Product Equality Declaration

We, **BYD Precision Manufacture CO., LTD**, declare on our sole responsibility for the product --
Model Name: T01C003 (FCC ID: E2K-T01C003) as below:

The main differences conducted to 2nd source are:

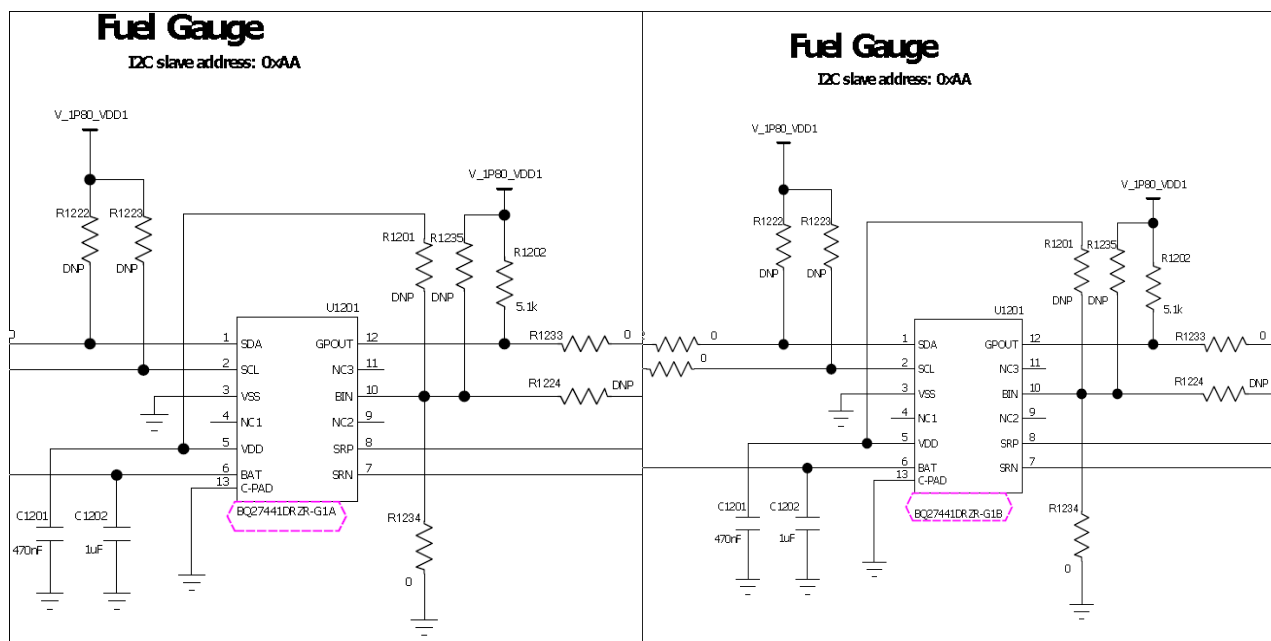
1. Add 2nd source of Adapter , P/N: LA10EUNM130 & LA10USNM130
2. Add 2nd source of DDR3, P/N: 11143382-00 & 11212957-00
3. Add 2nd source of EMMC, P/N: 11147188-00 & 11169784-00
4. Add 2nd source of LCD, P/N: 11218030-00 & 11170378-00 & 11218117-00
5. SW differences as below:

Change from YTP802A110830 to Venue7 3740_V1.84_140916-NoModem

P708-B1-BOT

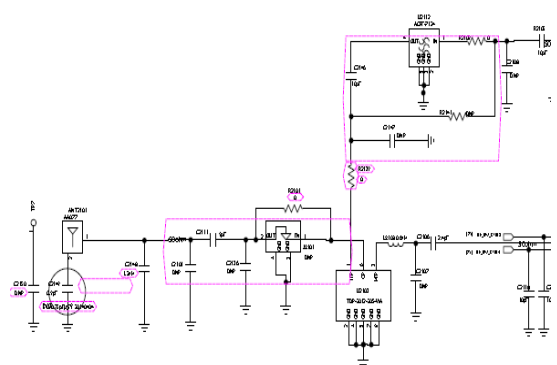
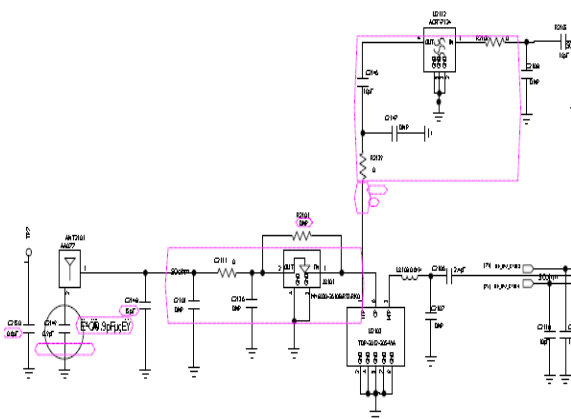
2. BT/WIFI antenna matching optimization.

C2149 change from 0402 0.75 PF to 0402 0.9 PF;
C2150 change from 0402 0.5 PF to 0402 DNP;
C2148 change from 0402 9 PF to 0402 1.2NH;
J2101 change from MM8030-2610B/RJ3/RK0 to DNP;
R2101 change from DNP to 0201 0R.

P708-B1-BOT

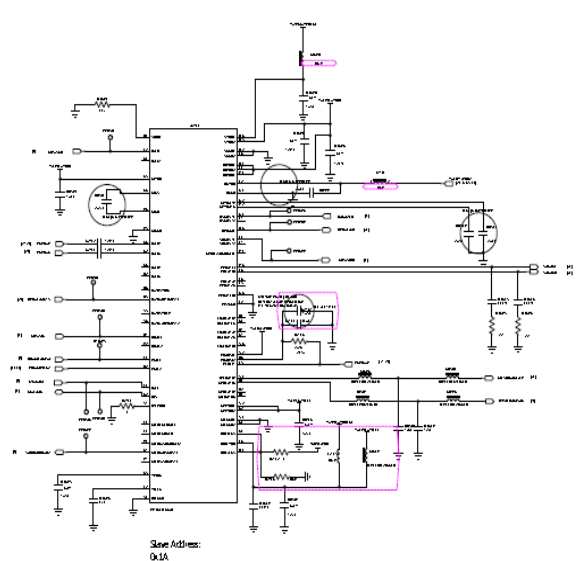
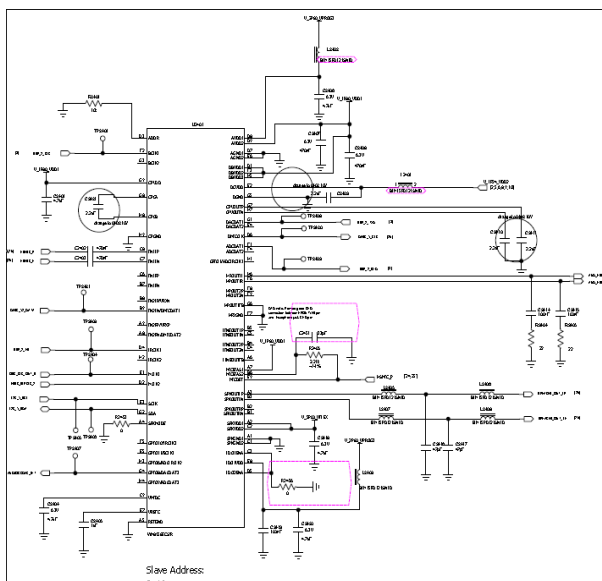
3. Optimization of audio circuit.

Add R2457 0R 0201 L2410;
Delete R2456, L2401, L2402, L2409.

P708-B1-BOT

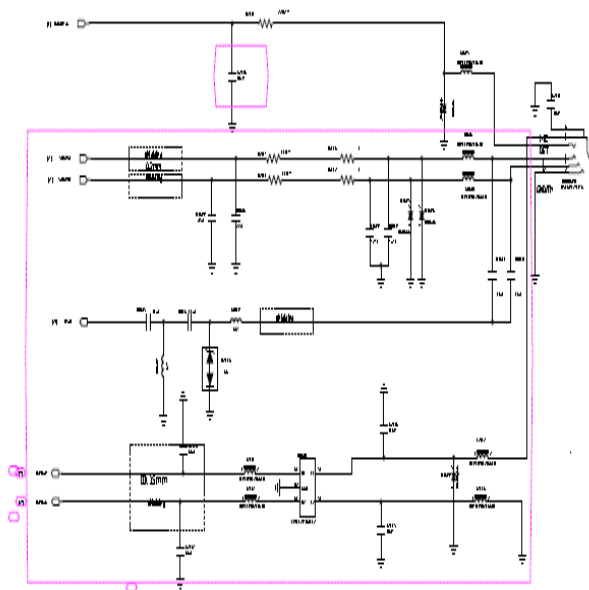
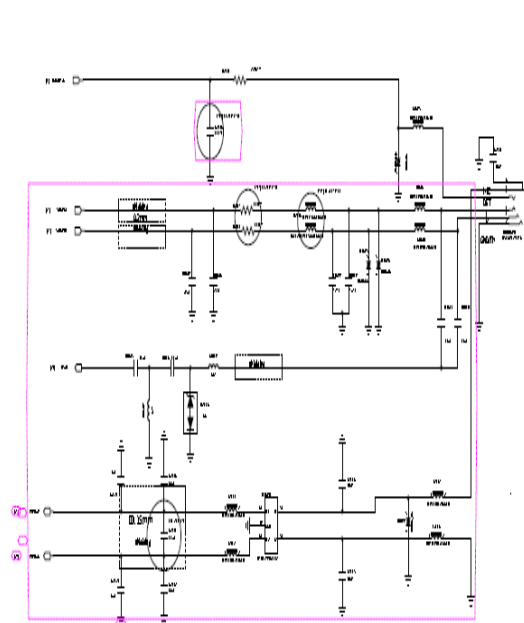
4. Optimization Headset interface circuit.

Add C2452 4.7uF 0402;
 R2506 change from 0R 0402 to BLM15AG601SN1D;
 R2507 change from 0R 0402 to BLM15AG601SN1D;
 C2506 change from 0201 DNP to 0201 100nF;
 R2504 change from 10R 0201 to 33R 0201;
 R2505 change from 10R 0201 to 33R 0201;
 Add C2515 33pF 0201.

P708-B1-BOT

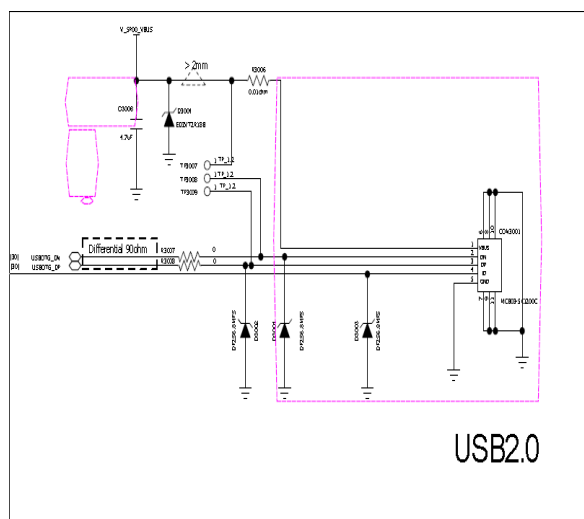
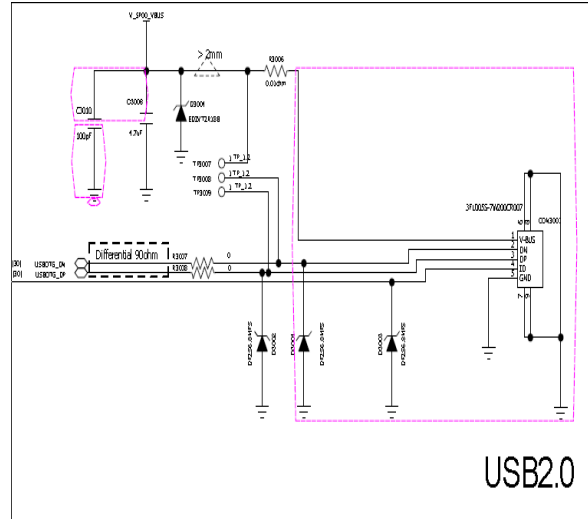
5. Replacing the USB connector.

Connector changed from CON3001 MCB03-5K1200C to 3FU005S-7W200CR007.

P708-B1-BOT

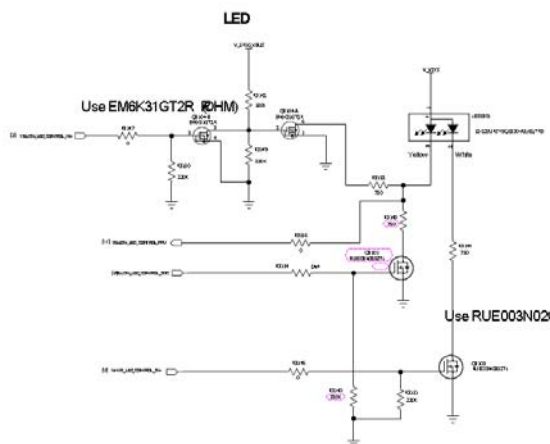
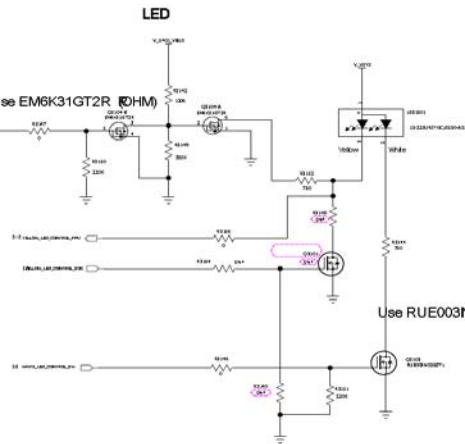
6. Optimization of LED lamp control circuit.

Q3101 change from RUE003N02GZTL to DNP;

R3148 change from 750 R to DNP;

R3140 change from 220K to DNP.

P708-B1-BOT

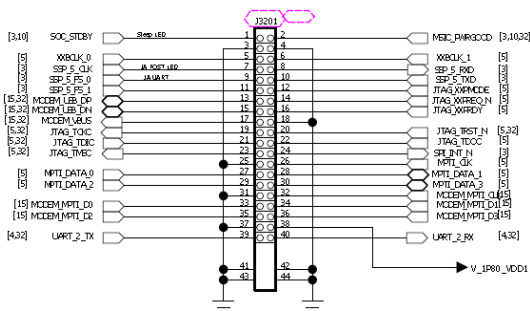
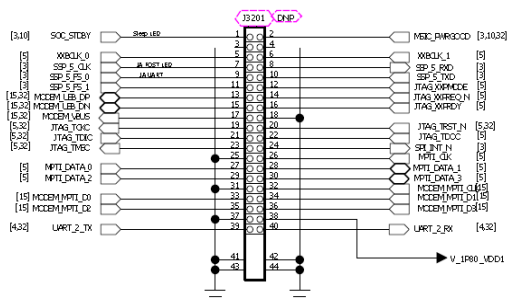
7. Delete Debug connector DNP J3201.
